## STAFF RECOMMENDATION

514 Monroe Street  
February 21, 2018

**Application:** New construction—infill and outbuilding  
**District:** Germantown Historic Preservation Zoning Overlay  
**Council District:** 19  
**Map and Parcel Number:** 08209006200  
**Applicant:** Chris Goldbeck, P. Shea Designs  
**Project Lead:** Melissa Baldock, melissa.baldock@nashville.gov

**Description of Project:** Application is to construct duplex infill and an outbuilding on a vacant lot. The outbuilding will not be used as a dwelling unit. The site is located within the National Register District Development Zone.

SITE PLAN  
1:40

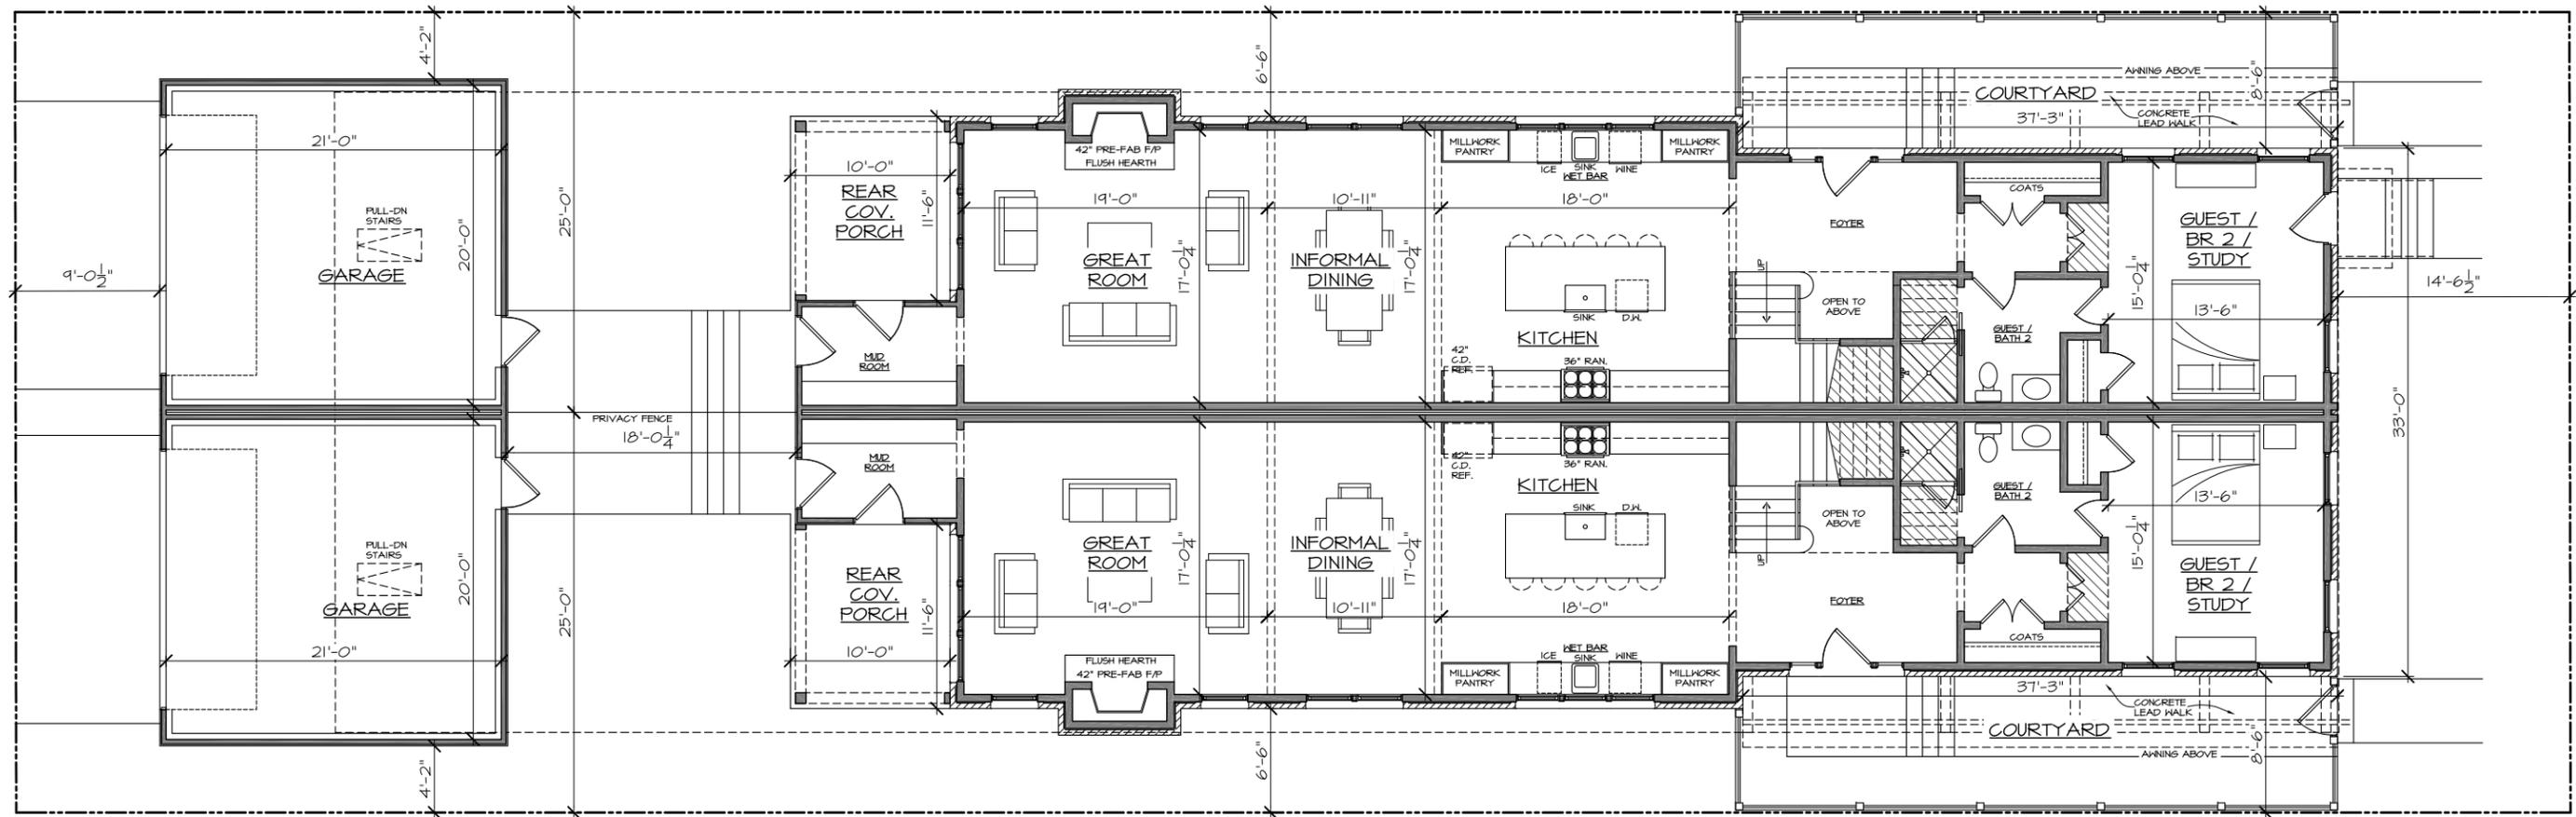
Sidewalks and Walkways: Staff recommends that a front walkway be added from the sidewalk to the front stoop so as to comply with Section III.E.11. of the design guidelines.
